**JAPAN's Comments on  
Backset Requirements of  
FMVSS 202aS  
Final Rule**

March '05  
JAPAN MLIT

# 1. Study of Variations in Backset Measurements

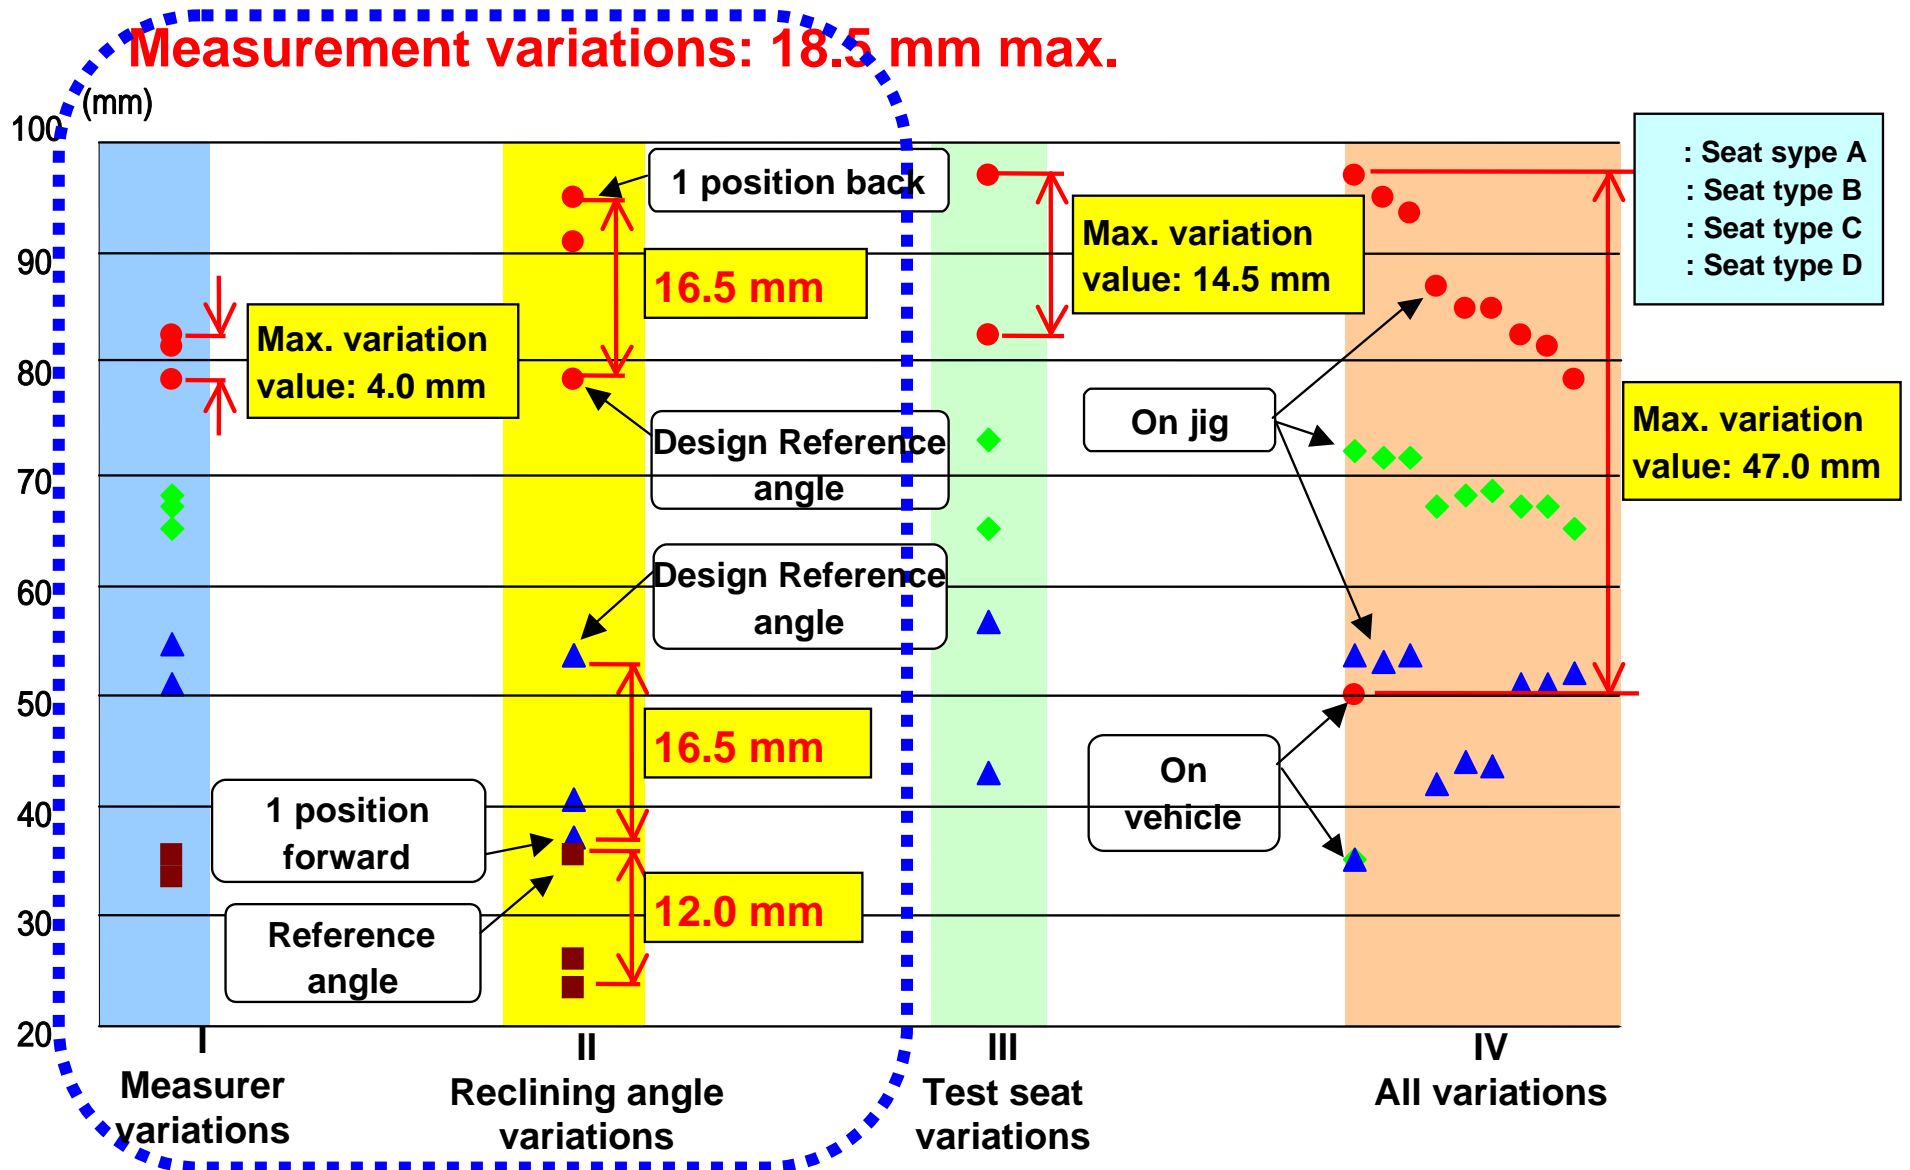
## (2) Results of determining variations

# 1. Study of Variations in Backset Measurements

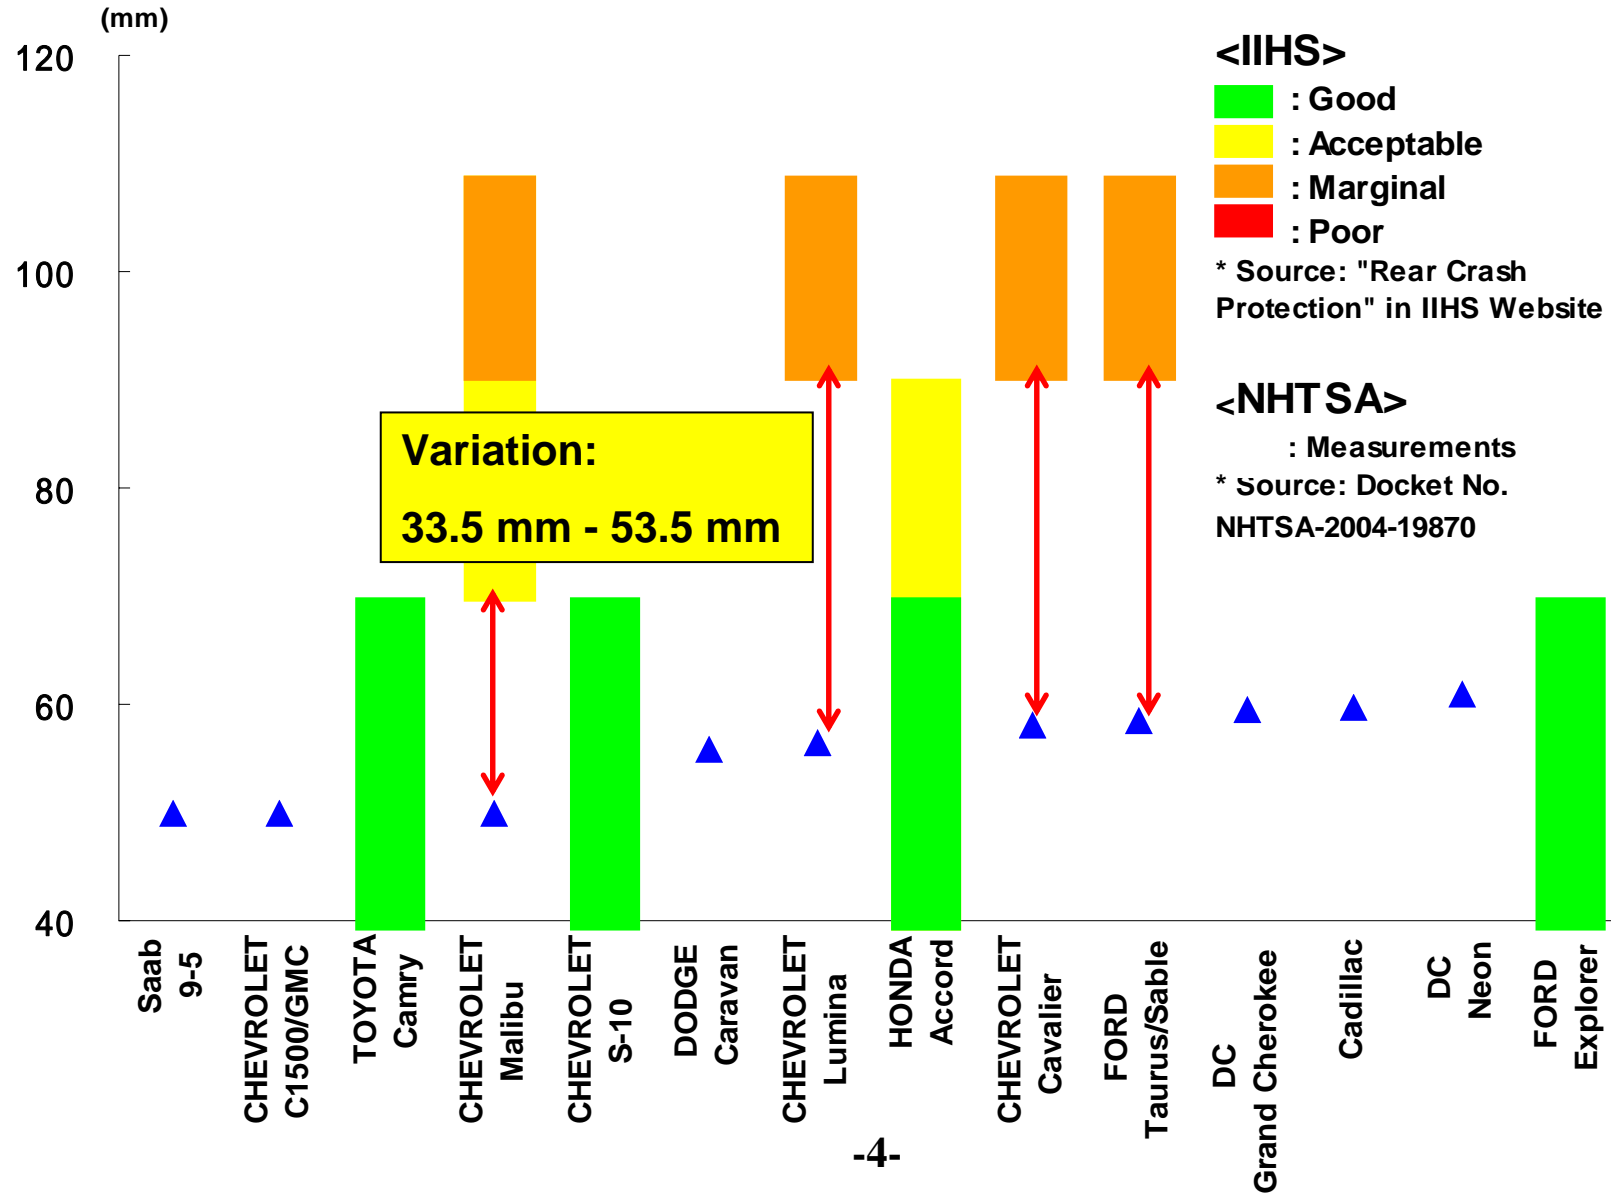
## (3) Comparison of measurements for 1999 model year vehicles between NHTSA and IIHS (for reference)

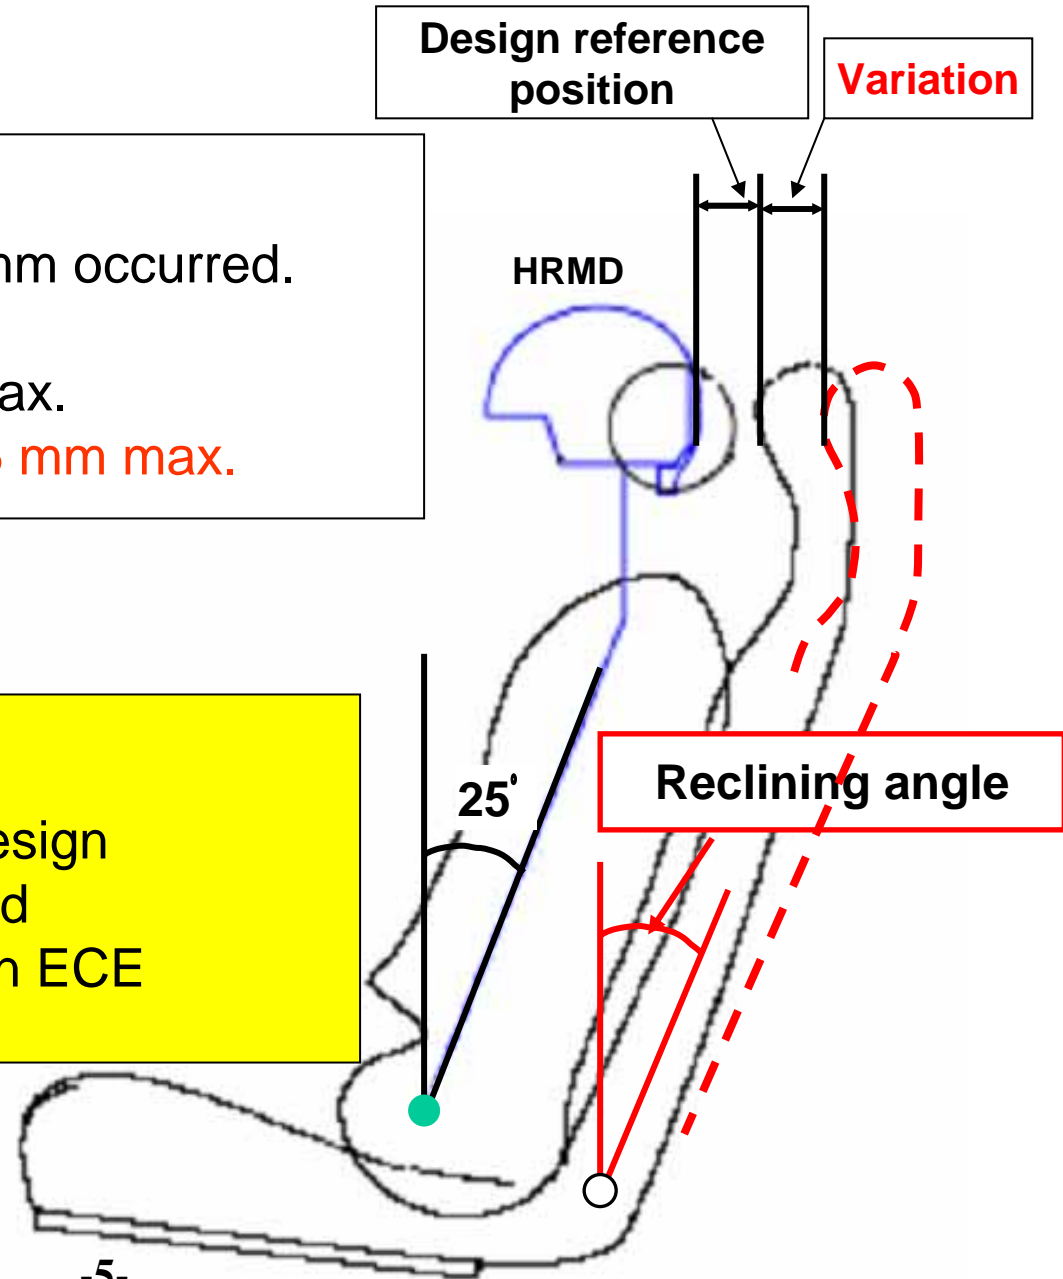
A maximum variation of 18.5 mm occurred.

- Measurers variation: 4.0 mm max.
- **Reclining angles variation: 16.5 mm max.**

To measure backset at the design reference position (with a fixed reclining angle) as specified in ECE

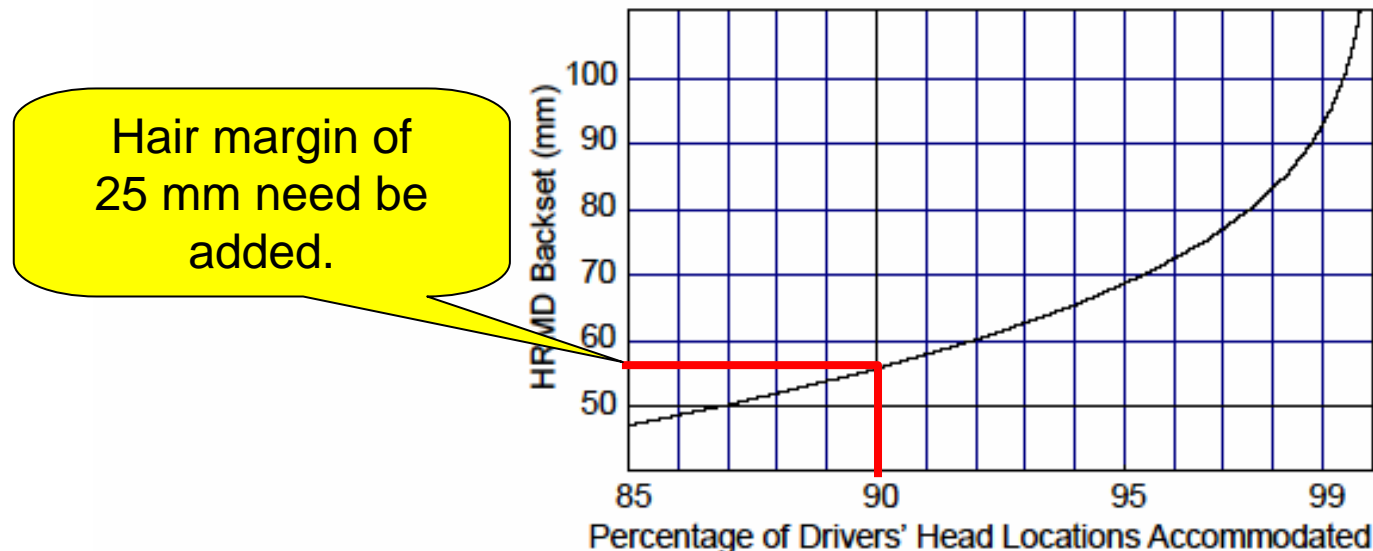
(2) Regarding the figure referenced by NHTSA (shown below), UMTRI clearly states that a **hair margin of 25 mm** need be added.

If head restraints complying with the NPRM were added to current driver seats, the head restraints would interfere with about 13 percent of drivers preferred head positions. The head restraints would contact the hair of about 33 percent of drivers, assuming a median hair margin at the back of the head of 25 mm. Figure 3 shows the percentage of drivers
